2.2.3 - Approved vs Proposed Ground Floor Elevation - Vine Lane (West)

2.2.4 - Approved vs Proposed Ground Floor Elevation - High Holborn (South)

3.1.1 - Approved vs Proposed Servicing Strategy Summary

5.1.1 - Museum Street Elevation (East) - Approved vs Proposed

5.1.3 - Vine Lane Elevation (West) - Approved vs Proposed

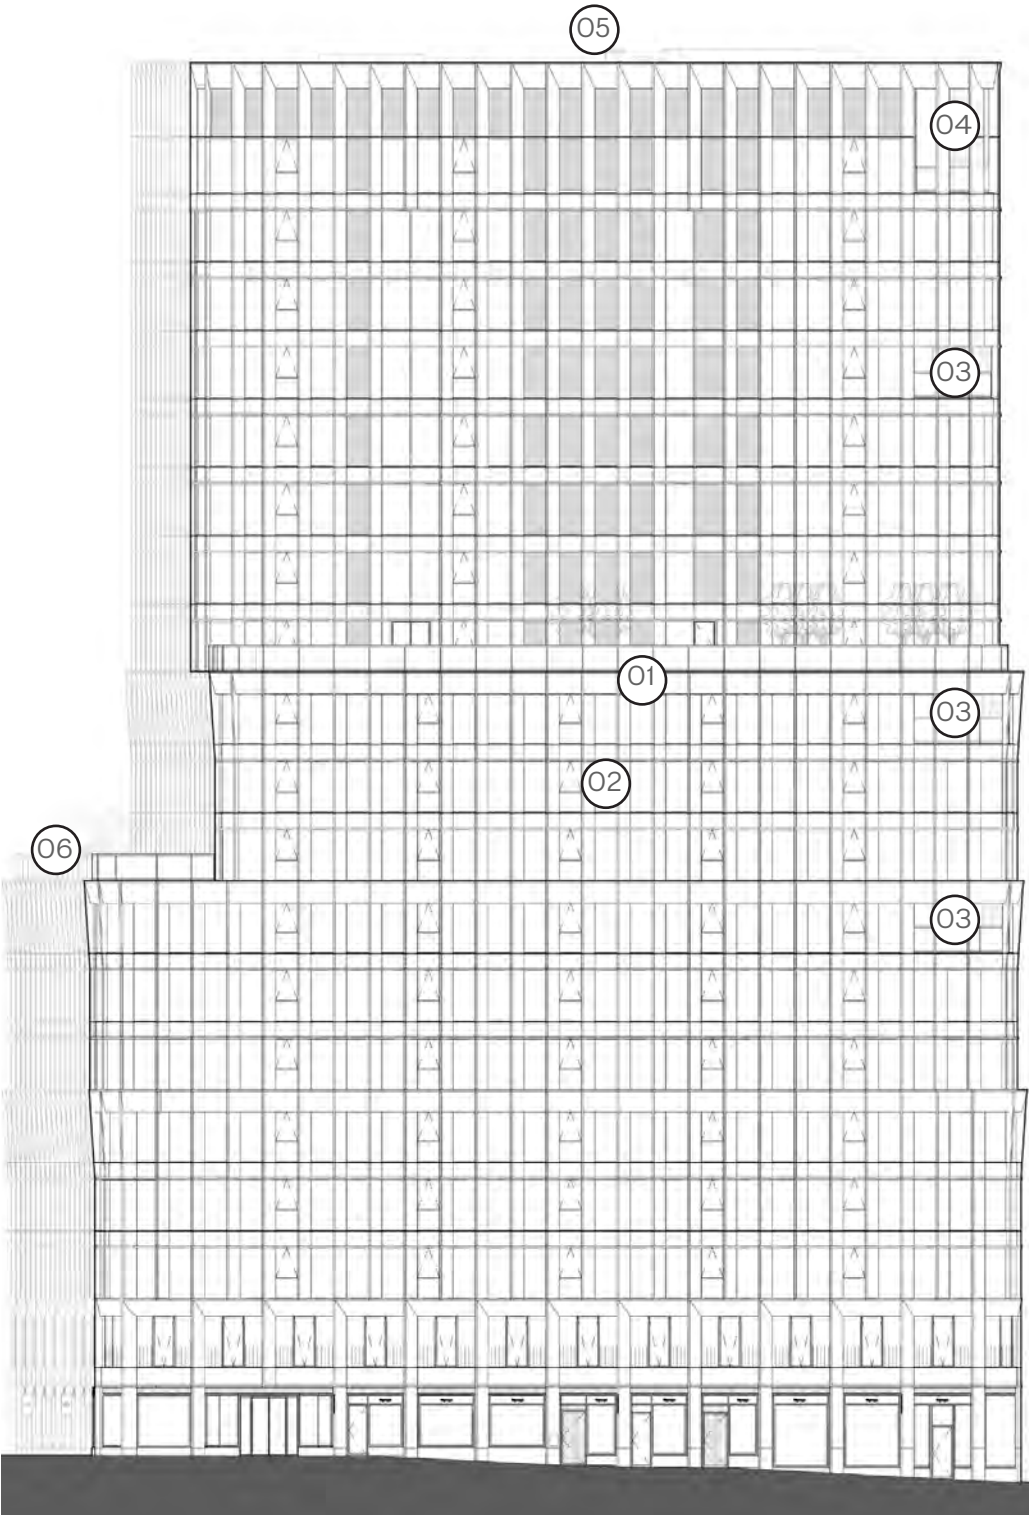
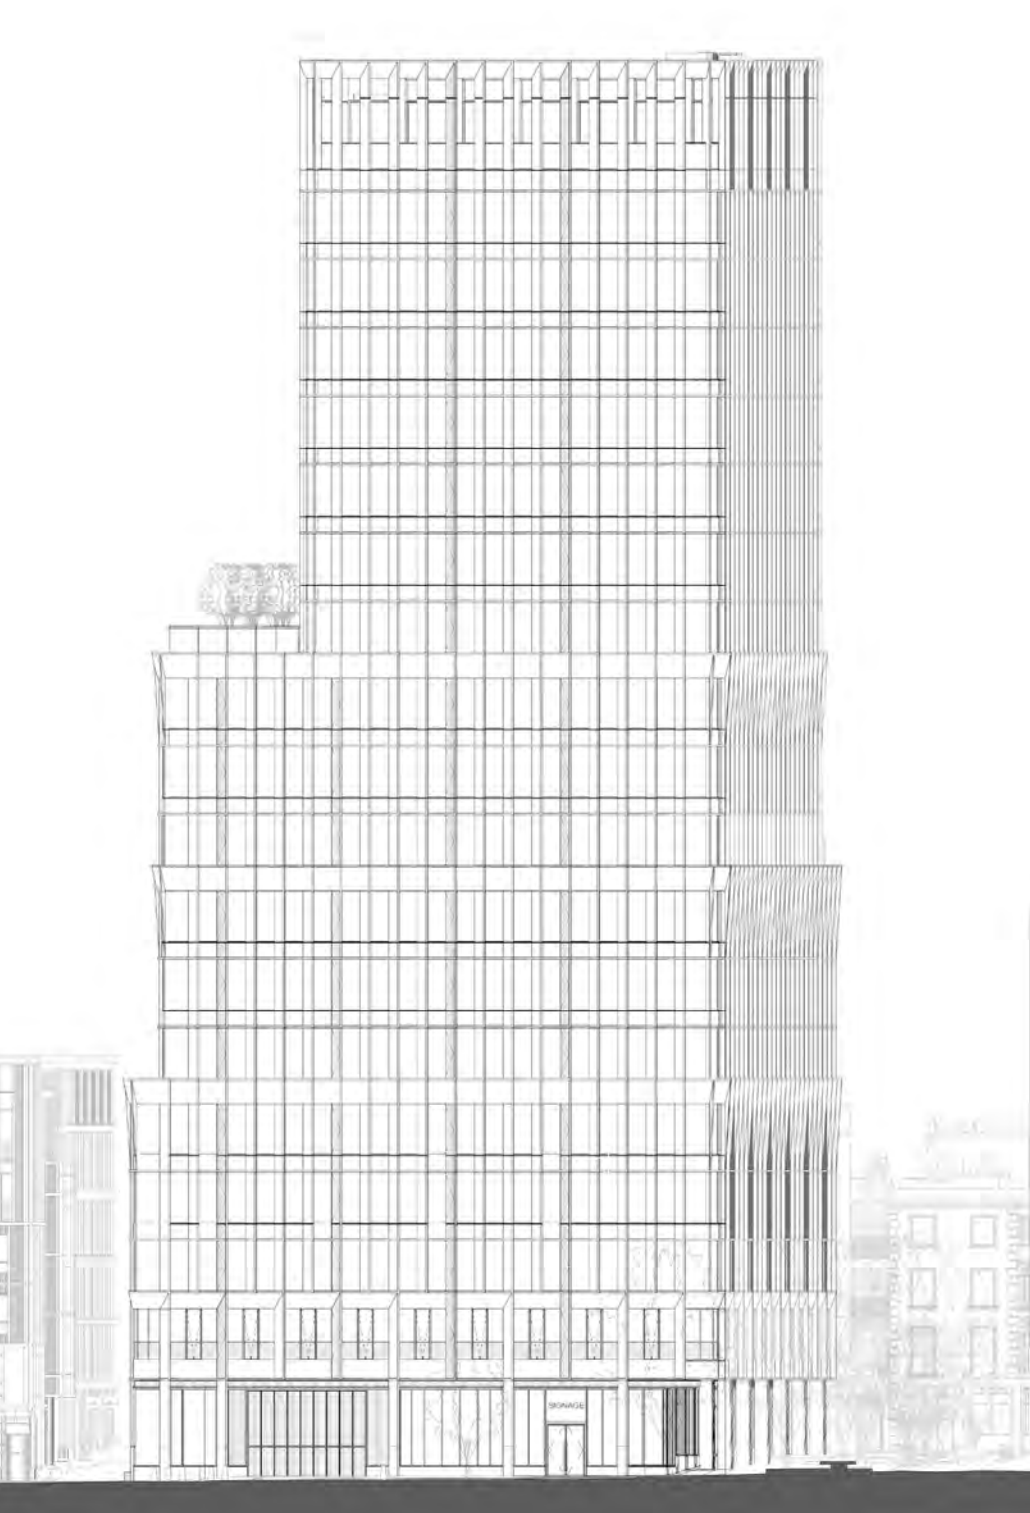
- 01. The facade design principles of the approved scheme remain the same with no change to materiality or tone. Note: Please refer to planning elevation drawings for facade materiality notes.

- 02. Operable panels across all facades have been replaced with openable windows within the glazed area to improve overall building thermal performance and futureproof flexibility.

- 03. Inset terraces introduced along the south elevation on Levels 7, 10, and 15.
- 04. Level 18 top floor south terrace size increased.
- 05. Building crown (top floor and building parapet) adjusted to accommodate changes to floor levels to incorporate additional plant at roof level. Building parapet height remains unchanged. Facade has been elongated and incorporates mirrored glazing.

- 06. Floor levels have been slightly adjusted, the overall height and massing remains unchanged - refer to pages 31-32 for a summary on levels adjustments.

- 07. Reduced internal facade depth by 100mm as a result of overall facade performance improvements.

5.1.4- High Holborn Elevation (South) - Approved vs Proposed

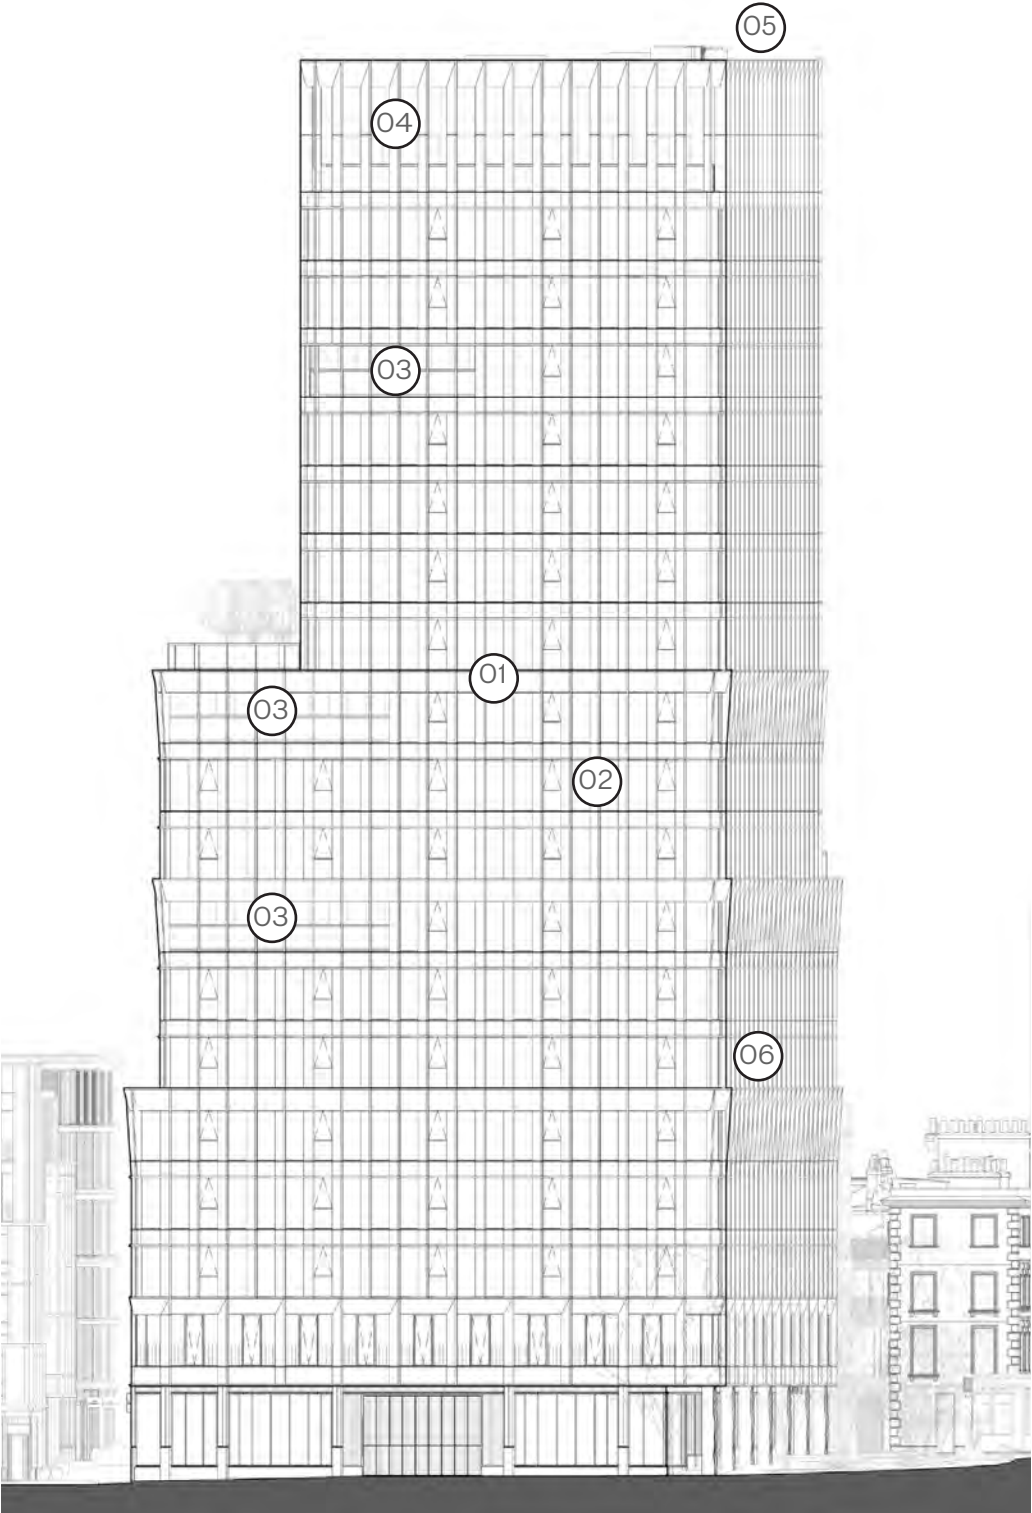
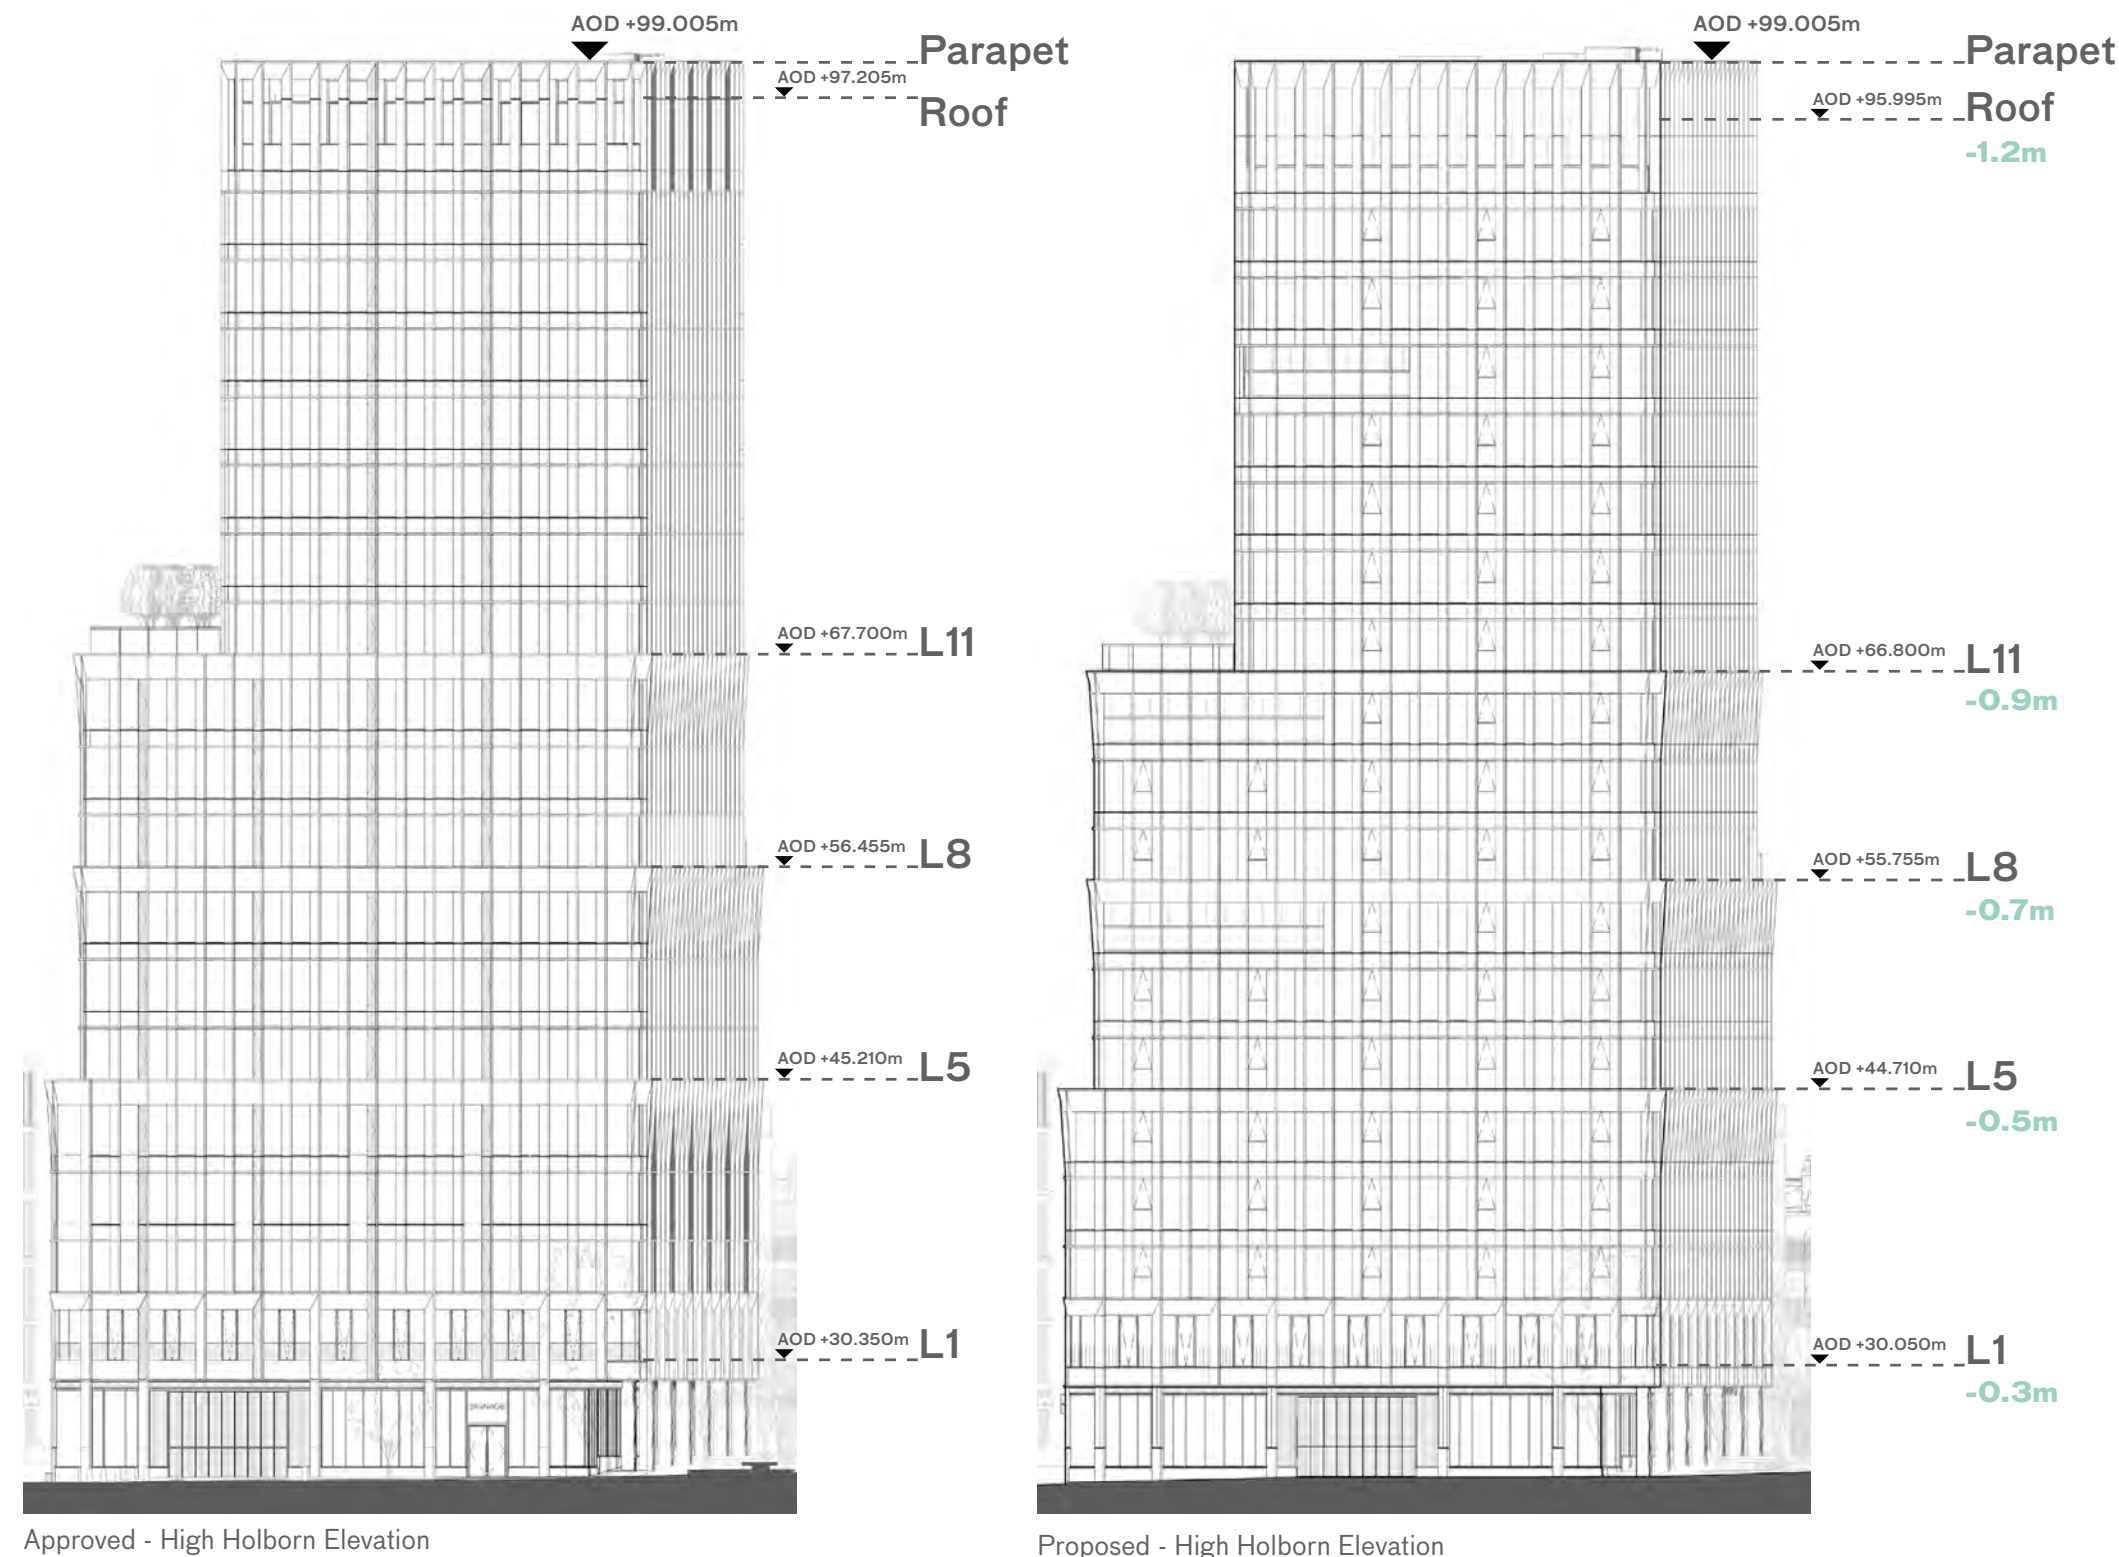
- 01. The facade design principles of the approved scheme remain the same with no change to materiality or tone. Note: Please refer to planning elevation drawings for facade materiality notes.

- 02. Operable panels across all facades have been replaced with openable windows within the glazed area to improve overall building thermal performance and futureproof flexibility.

- 03. Inset terraces introduced along the south elevation on Levels 7, 10, and 15.
- 04. Level 18 top floor south terrace size increased.
- 05. Building crown (top floor and building parapet) adjusted to accommodate changes to floor levels to incorporate additional plant at roof level. Building parapet height remains unchanged. Facade has been elongated and incorporates mirrored glazing.

- 06. Floor levels have been slightly adjusted, the overall height and massing remains unchanged - refer to pages 31-32 for a summary on levels adjustments.

- 07. Reduced internal facade depth by 100mm as a result of overall facade performance improvements.

5.2.1 - Levels Comparison - High Holborn Elevation

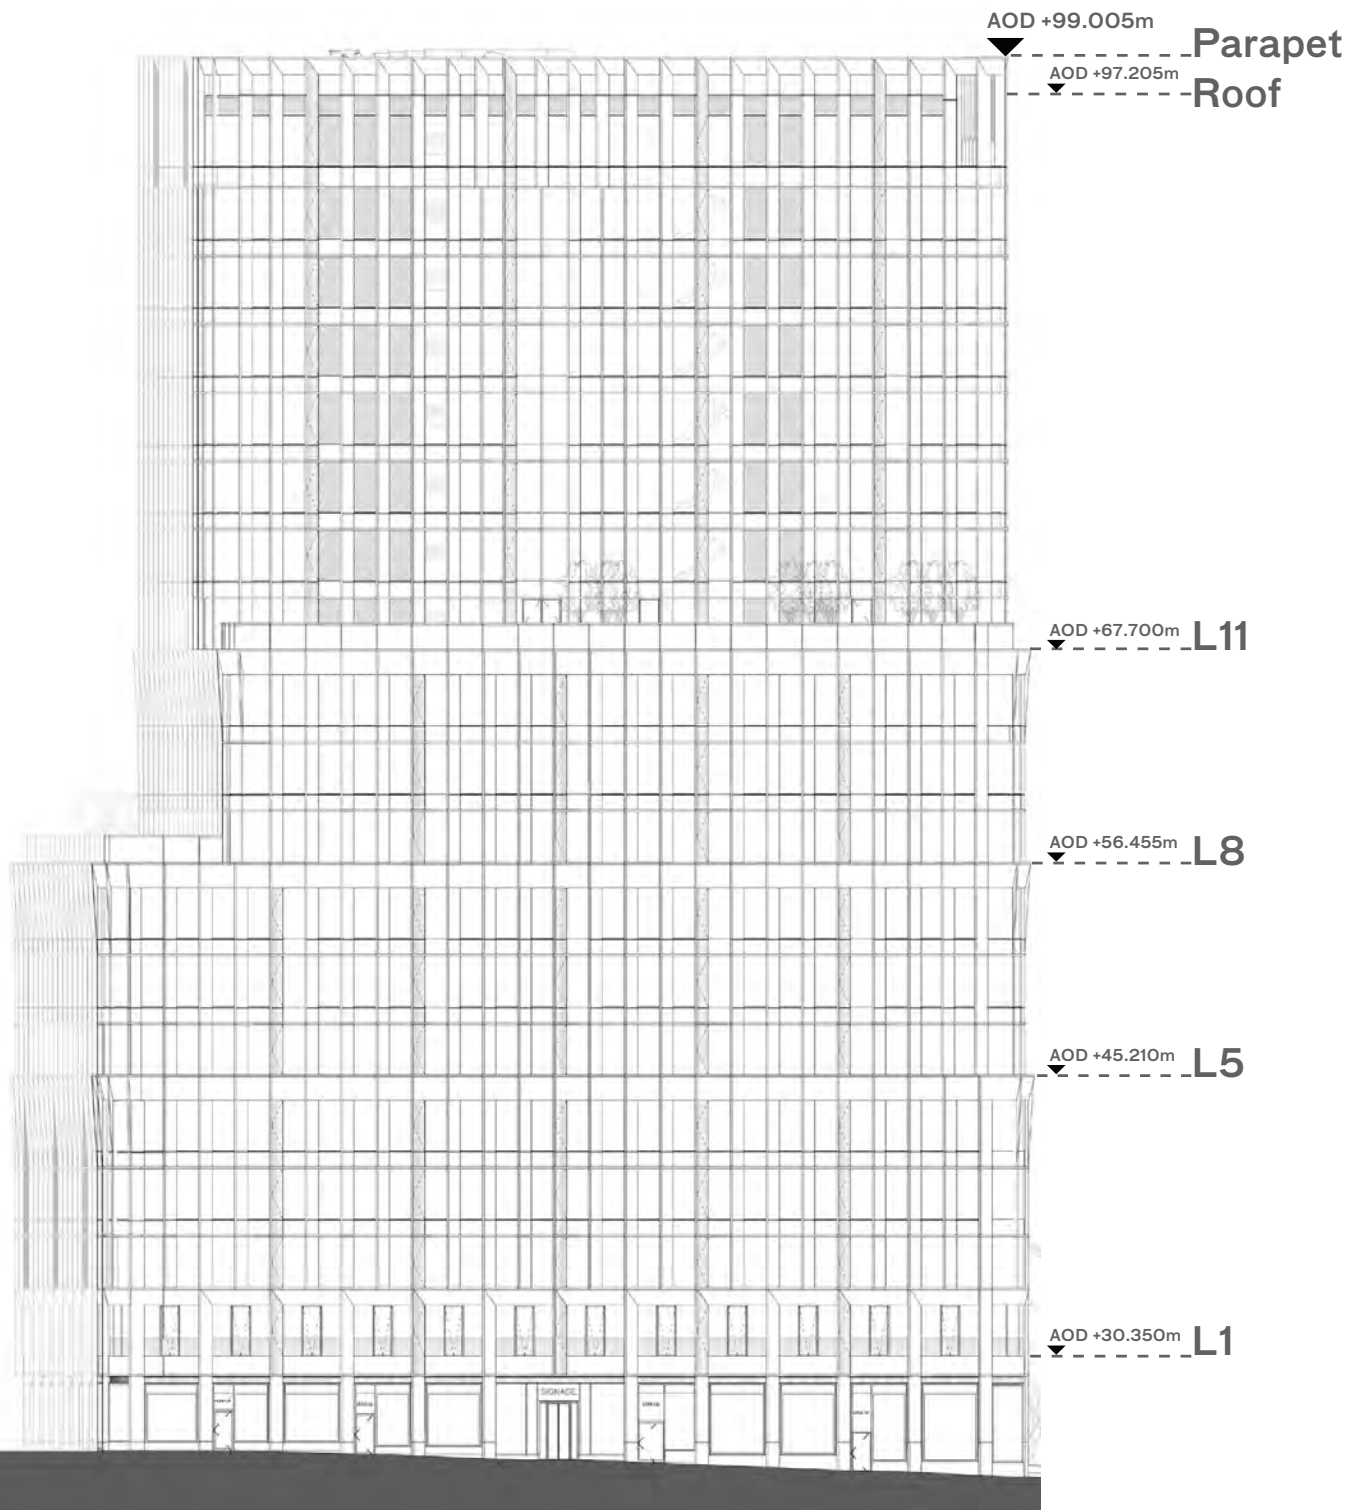
O1. Building levels have been adjusted to suit detail development of MEP and Structural design strategies for the building. Parapet AOD height and massing remain unchanged.

O2. The Parapet proportion has been elongated by 1.2m and incorporates mirrored glazing. Building parapet height remains unchanged.

5.3.2 - External Views Comparison - High Holborn

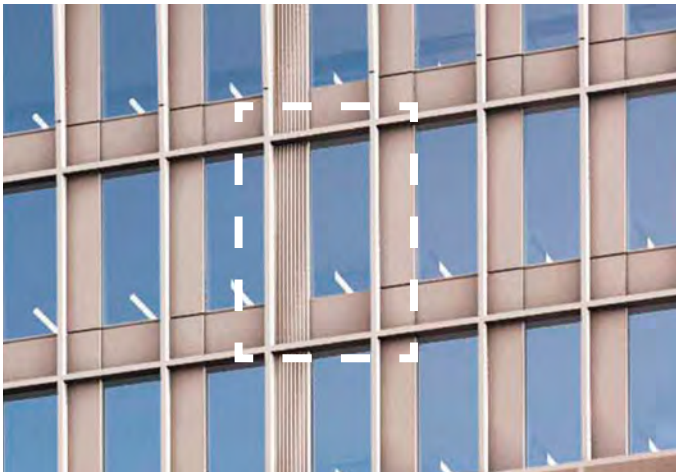
O1. Building levels have been adjusted to suit detail development of MEP and Structural design strategies for the building - the overall building height and massing remains unchanged.

O2. Operable vent panels to office floorplates have been replaced with openable windows (improving the overall facade and building performance).

O3. New inset terraces have been introduced on levels 7, 10 and 15. The terrace on level 18 has been increased in plan depth, still remains as full width of the High Holborn elevation.

O4. The building crown has been adjusted to match the adjusted building levels.

O5. Mirrored glass has been introduced to the building crown to screen plant equipment, and add character to the building top.
